TECHNICAL BULLETIN

DATE: 06 MARCH 2008

* Supersedes Technical Bulletin TB900-027, dated 23 June 2006. Revised to change aircraft affected, warranty policy, replacement parts/supplies, to show the different configurations of the external power box assembly, correct references, and add compliance recording form. Aircraft that are in compliance with Technical Bulletin TB900-027 meet the intent of this revision.

ELECTRICAL NOISE SUPPRESSION MODIFICATION

Figure 1. External Power Box Assembly Relay Configurations

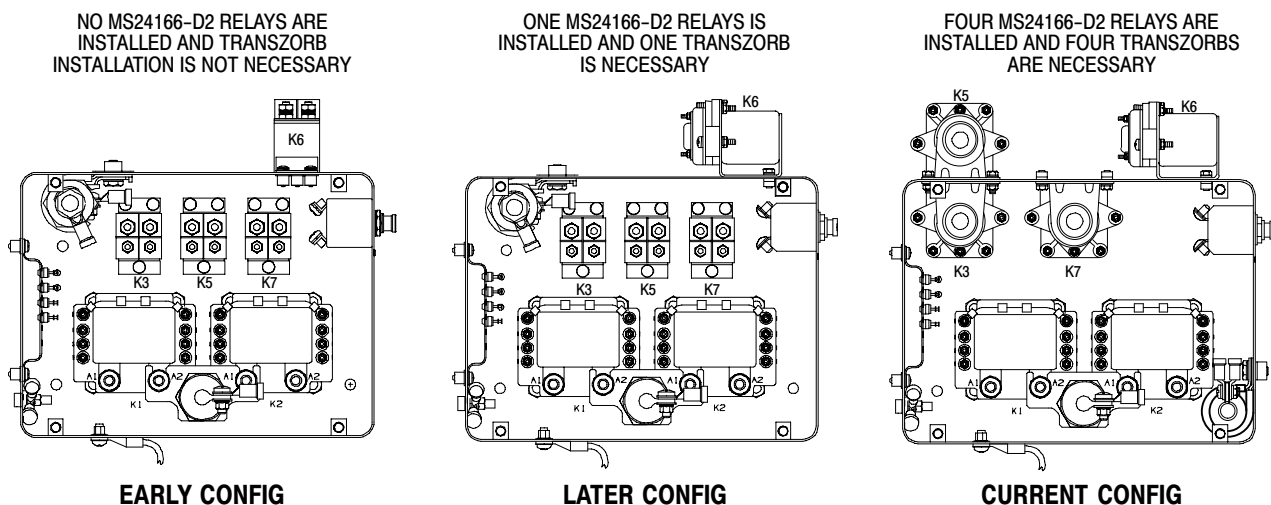
- The external power box assembly (A610) is used with the forward battery installation.
 - There are three different external power box assembly configurations. The three configurations are with no MS24166-D2 relay, one MS24166-D2 relay, or four MS24166-D2 relays.
- (1). Look at the external power box assembly to find if transzorbs are necessary (Ref. Figure 1).

- Transzorbs are not necessary for the **EARLY CONFIG** external power box assembly.
- It is not necessary to remove the external power box assembly if it is the **LATER CONFIG**.

- (2). If necessary, remove external power box assembly (Ref. CSP-900RMM-3, Section 96-00-00, External Power Box Assembly Removal).
- (3). Find relays K3, K5, K6, and K7 and if necessary, install transzorb on relay (Ref. Figure 2).
- (4). If necessary, install external power box assembly (Ref. CSP-900RMM-3, Section 96-00-00, External Power Box Assembly Installation).

Figure 2. Electrical Noise Suppression Modification

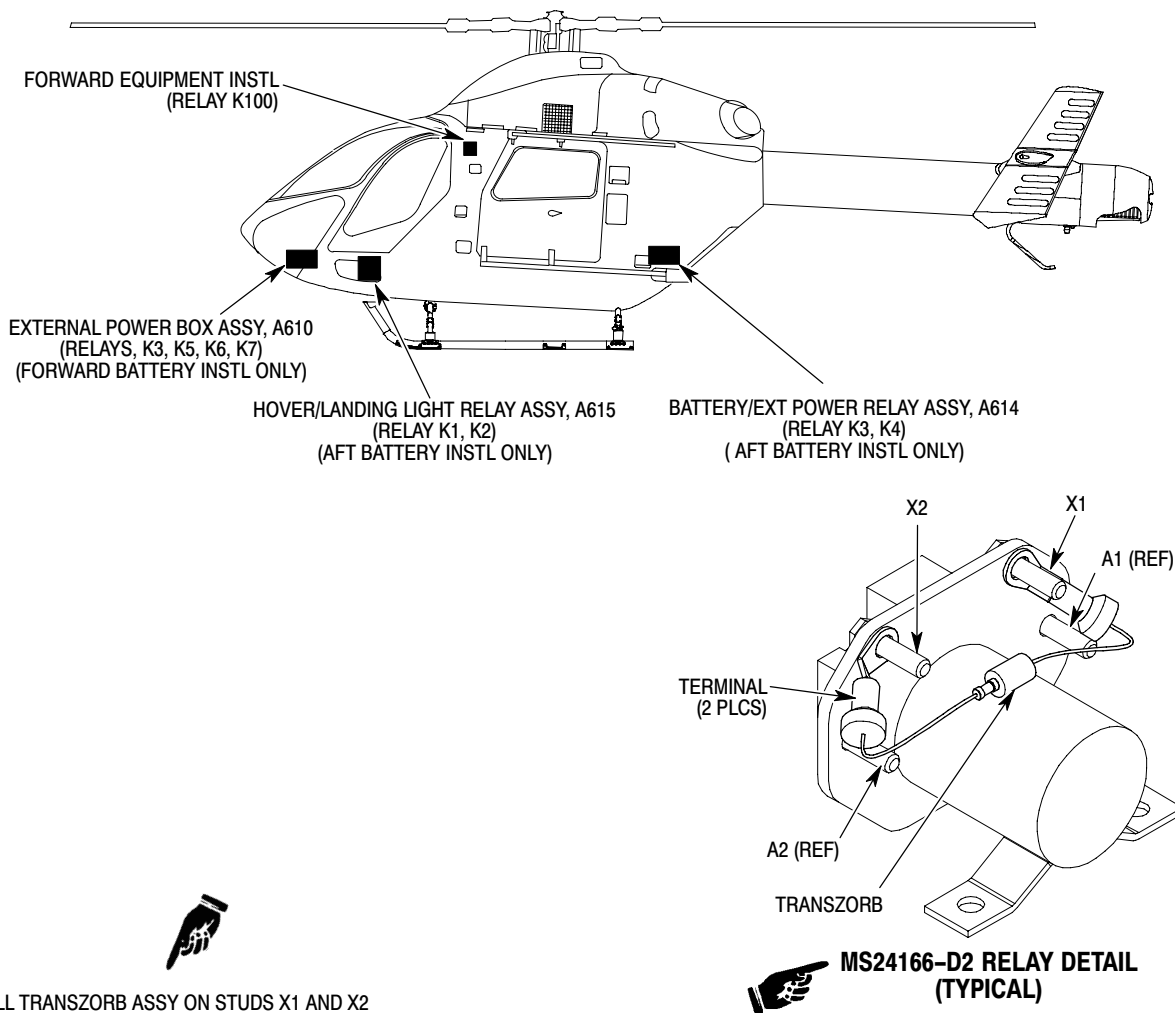
Electromagnetic Interference (EMI) affecting a customer optional, non flight essential electronic display system in an MD900 helicopter has been reported. The source of the EMI has been identified as a relay in the hover/landing light relay assembly. The same type of relay is used in other helicopter systems. This Bulletin adds electrical noise suppression to the subject relays.

Procedures in this Bulletin provide owners and operators with information pertaining to installation of a transorb across the coil of the affected relays.

- (2). Remove bulkhead cover to access K100 power relay.
- (3). Install transzorb on K100 relay (Ref. Figure 2).
- (4). Install bulkhead cover.
- (5). Restore power to helicopter (Ref. CSP-900RMM-3, Section 96-00-00, Restore Power).

1. INSTALL TRANSZORB ASSY ON STUDS X1 AND X2
2. DO NOT BEND TERMINALS MORE THAN 90 DEGREES.
3. TRANSZORB CAN BE INSTALLED IN EACH OF THE TWO DIRECTIONS.
